Applicant: Integrity Commercial Capital, LLC (Owner)

Location: 300 West 83<sup>rd</sup> Street

Request: Final Site and Building Plans for a 1,536 square-foot office addition and associated site improvements at an existing industrial building.

Case PL2020-206

**Figure 1: Parking Encroaching into Shared Access Easement**

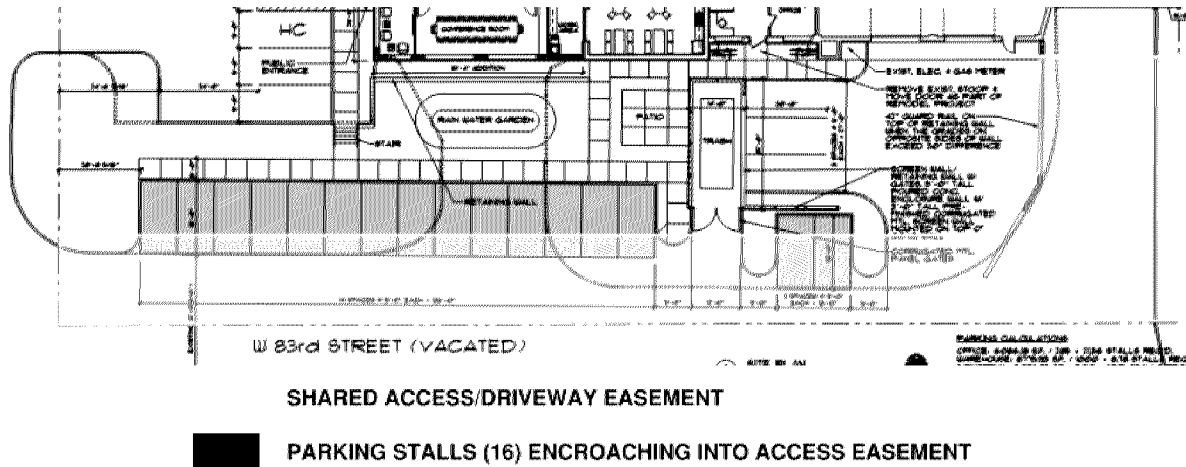
Based upon the internal renovations and building addition proposed, the City Code requires the facility to have 41 off-street parking spaces. Table 2 provides an analysis of the required quantity of parking for the proposed industrial facility. The proposed site plan includes 42 off-street parking spaces, which would meet the Code-requirement. However, 16 of the proposed 42 parking spaces located along the southern boundary encroach into the shared access/driveway easement, as shown in Figure 1. Staff analyzed the existing shared access easement, and it is strictly for driveway purposes only, which would not allow for the surface parking encroachment. As a result, parking stalls that encroach into the access easement may not be counted towards the parking supply. To allow these 16 parking stalls to be counted towards the overall parking supply, the parking stalls

must be removed from the easement area or the shared access easement be revised, which will require the consent of the property owner of 8301 Grand Avenue South. The easement width could be reduced, so long as a minimum drive aisle (24 feet) is maintained, or the easement can be revised to allow for the encroachment of parking stalls. Staff is recommending a condition that the applicant provide a revised access easement along the southern boundary prior to the issuance of any permits to resolve the parking encroachment issue.

3. Prior to Permit Access, circulation and parking plans must be approved by the City Engineer.
4. Prior to Permit A revised private common driveway/access easement or agreement with 8301 Grand Avenue South resolving the parking stall encroachment conflict be filed with Hennepin County and proof of filing provided to the Engineering Division.
